# MIAMI BEACH

### Staff Report & Recommendation

SUBJECT: DRB18-0333  
**5500 Collins Avenue – Towerhouse Condominium**

**DRB18-0333, 5500 Collins Avenue.** The applicant, Towerhouse Condominium, Inc., is requesting Design Review Approval to replace the existing precast baluster railings system along the balconies of the west (Indian Creek), north and south elevations of the existing 25-story building with all clear glass railings.

Details of typical floor plan from original plans, Permit 88131

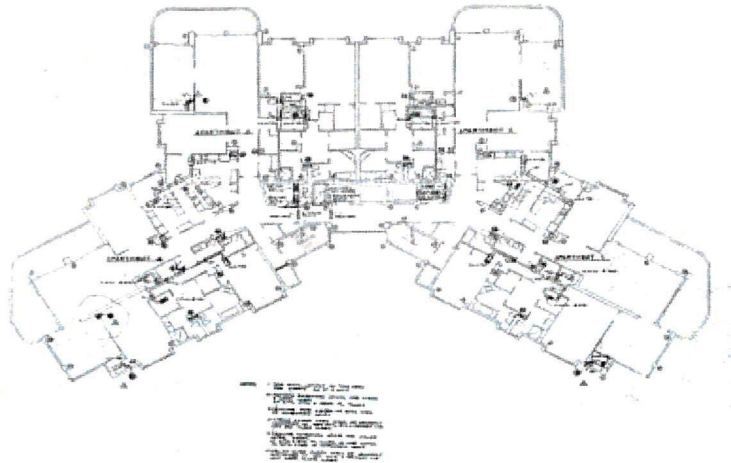
The original design for the Reiff-Fellman building contained precast concrete balusters with a tapered fin design that reflect the shape of the building. The pre-cast railings are a character defining element of the building's architecture. Nevertheless, the removal of the decorative

ocean. The pre-cast concrete fin detail that adorns the existing balconies occurs mostly on the less visible elevations, the north, south and west, of the building. However, given that the rear portion of the balconies along the side elevations of the building are visible from the street, the Board requested that the applicant further investigate bringing into the new design of the railings some of the verticality provided by the pre-cast fin detail.

As noted previously, staff does not object to the removal of the precast concrete portions of the balcony wall and the installation of a glass railing replacement. However, the design options presented by the applicant do not successfully enhance the vertical gesture lost by the precast fins, especially at the portion of the balconies that are visible from Collins Avenue, and essentially the front elevation of the tower. Staff recommends that the architect further investigate the design of the railings to arrive at a design solution that responds to both the Board's request for vertical articulation and the applicant's desire for transparency.

Based on this analysis, staff recommends continuance of the application to a future date in order to address staff concerns.
